# PEX 8509

PCI Express Switch

**Silicon Revisions and Errata List**

**Version 1.1**

### **Erratum #4 – Dropped SKIP Ordered Set when Exiting L1 Power Management State**

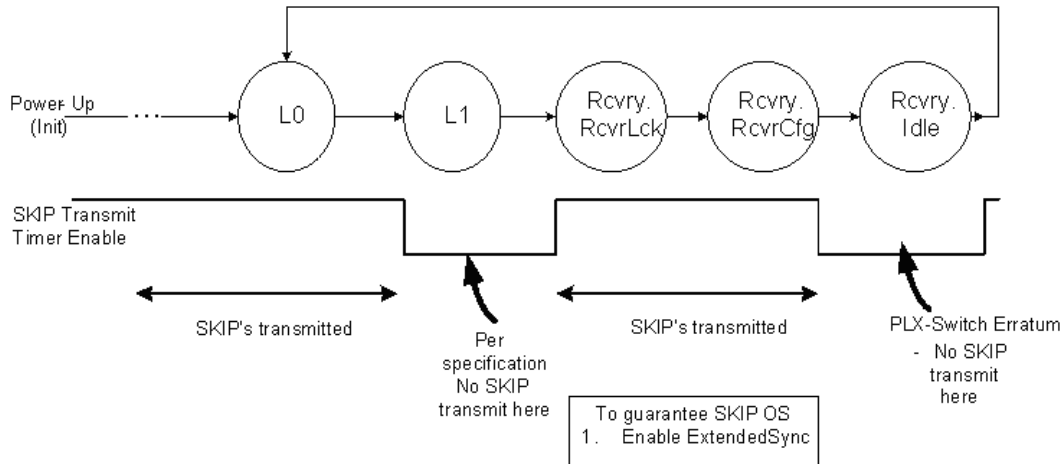
When exiting from the L1 Power Management (PM) state, there is a narrow window (recovery.idle state) during which SKIP ordered sets are not transmitted. The exit from L1 PM state steps through 3 sub-states:

- 1) rcvry.rcvrlock
- 2) rcvry.rcvrconfig
- 3) rcvry.idle.

For the duration in which the link is in Recovery.idle state (waiting for receipt of 8 Idle symbols) there will be no SKIP ordered sets transmitted. Note, SKIP symbols will be transmitted properly when entries into recovery sub-states are from another (L0 or L0s) state.

The Figure below illustrates the behavior.

One of the following workarounds can be used with upstream devices whose PHYs require SKIP ordered sets to exit its L1 state.

1. Disable the PEX 8509 upstream port's entry to L1 state for ASPM L1 [78h[1:0]] and PCI PM (device specific offset 1E0[7]) mechanisms.
2. Enable the ExtendedSync mode (Offset 78h[7]), to guarantee SKIP ordered sets in the RcvrLck and RcvrCfg states (shown above)
